SUBJECT: COMANCHE PEAK NUCLEAR POWER PLANT, UNITS 3 AND 4  
DOCKET NUMBERS 52-034 AND 52-035  
RESPONSE TO REQUEST FOR ADDITIONAL INFORMATION NO. 5004, 5005,  
AND 5029

Luminant Generation Company LLC (Luminant) submits herein the response to Request for Additional Information (RAI) No. 5004, 5005, and 5029 for the Combined License Application for Comanche Peak Nuclear Power Plant Units 3 and 4. These RAIs involve Inspections, Tests, Analyses, and Acceptance Criteria (ITAAC).

**SUBJECT:** COMANCHE PEAK NUCLEAR POWER PLANT, UNITS 3 AND 4  
DOCKET NUMBERS 52-034 AND 52-035  
SUPPLEMENTAL INFORMATION FOR THE RESPONSE TO REQUEST FOR  
ADDITIONAL INFORMATION NO. 4760

SUBJECT: COMANCHE PEAK NUCLEAR POWER PLANT, UNITS 3 AND 4  
DOCKET NUMBERS 52-034 AND 52-035  
RESPONSE TO REQUEST FOR ADDITIONAL INFORMATION NO. 4678

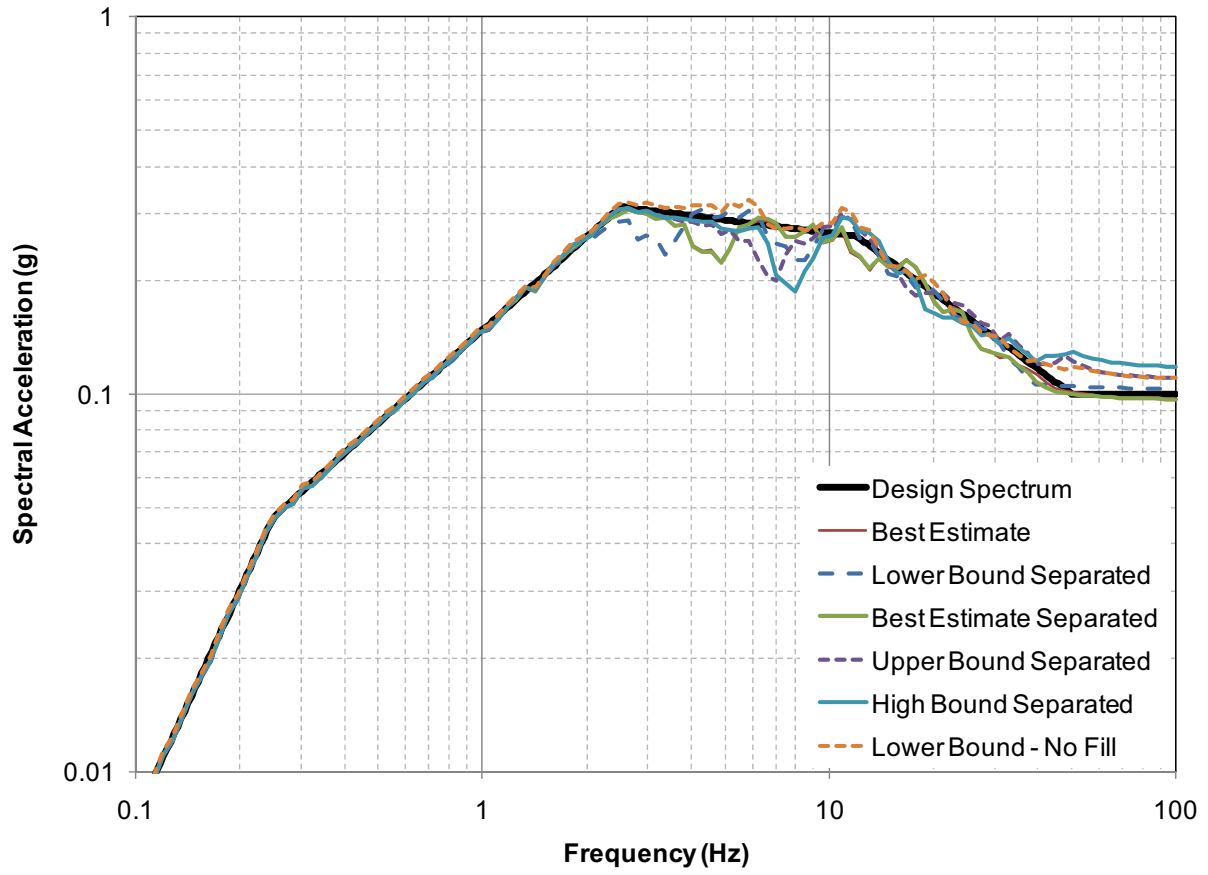
Specifically, the staff would like to know how the Squaw Creek Reservoir slope may affect the SSI analysis and the stability of Unit 3 ultimate heat sink (UHS) structures, which are located near the reservoir slope, as shown in FSAR Figure 2.1-201.

Also, explain how the retaining wall (as shown in figure 2.5.5-206 of the FSAR) was considered in the UHS SSI analysis. Determine whether failure of the wall would affect the lateral stability of the UHS safety-related structure.

In the response to this question (ML102290040), Figure 1 presented the in-structure response spectra (ISRS) obtained from the SSI analyses of the UHSRS basin foundation slab, for the best estimate and lower bound no-fill cases and for the embedded cases (lower bound separated, best estimate separated, upper bound separated, and high bound separated), together with the horizontal input design response spectra for the 0.1 Hz to 50 Hz frequency range.

The revised Figure 1 presented below includes data for the 50 Hz to 100 Hz range as requested by the NRC staff. Figure 1 shows that the SSI effects on the seismic response of the UHSRS are small. Since variations in surface geometry and properties of the limestone would affect the soil support and the response is shown to be insensitive to the variation in soil support conditions, responses of the UHSRS are not considered to be sensitive to variations in the surface geometry or properties of the limestone due to the presence of the reservoir. Therefore, the presence of the reservoir slope does not impact the SSI results and the use of a horizontally infinite half-space. Further, the consideration of a broad range of embedment conditions ensures that the ISRS results and the design of the UHSRS envelope the actual site conditions.

**Figure 06.04-9-1. Chlorine Release - CHEM Results (Concentration inside Control Room)**

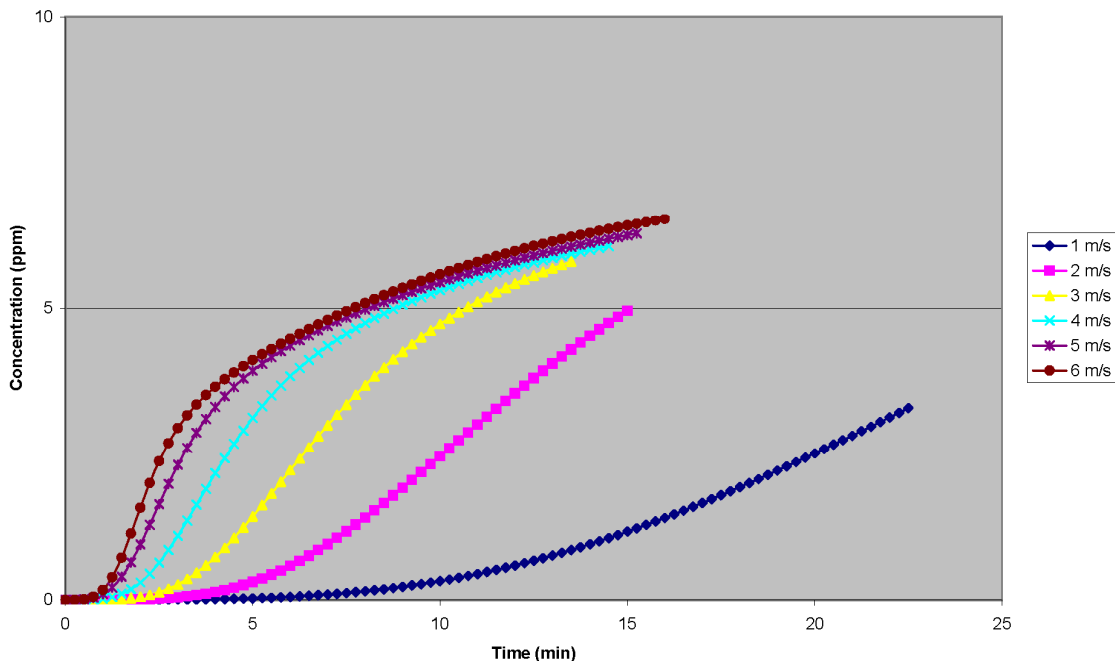
FSAR Sec. 6.4.4.2 states that the meteorological condition assumed for the analysis is conservatively set at G stability and 2.5 m/s wind speed. Provide HABIT run results to demonstrate that the selected data set is conservative.

FSAR Sec. 6.4.6 concludes that no instrumentation to detect and alarm is required. This conclusion is based on the HABIT run that no hazardous chemical concentrations will exceed the IDLH. To demonstrate that the IDLH has not been exceeded, it is important to verify that the HABIT calculation has not terminated before the peak concentration has occurred. Please verify that the HABIT calculations show the concentration has peaked and is decreasing (or has leveled-off) before the calculation has terminated. Provide the numeric output of the portion of HABIT run that demonstrates the peak chemical concentration in main control room has been calculated.

3. The HABIT sensitivity analysis compared results at Classes E, F and G stability and demonstrated that the use of Class G stability is the most conservative. However, as Class G stability occurs less than 5% of the time at the CPNPP site (see Table 06.04-9-1 below), Class F stability is utilized in the HABIT sensitivity analysis per Appendix A of RG 1.78. HABIT sensitivity analyses for Class F stability and a range of wind speeds from 1 m/s to 6 m/s was performed to determine the worst wind speed. A summary of these results are located in Figure 06.04-9-1, which are the results from CHEM (a determination of the chemical concentration inside the control room) and Figure 06.04-9-2, which are the results from EXTRAN (a calculation of the chemical concentration outside the control room at the air intake). The worst-case wind speed was 6 m/s as shown in Figures 06.04-9-1 and 06.04-9-2, below.

4. The new HABIT CHEM analysis results demonstrate that the calculation is asymptotically approaching a maximum for the worst case 6 m/s wind speed (see Figure 06.04-9-1). For lower wind speeds with lower calculated control room concentration curves that have not peaked, the
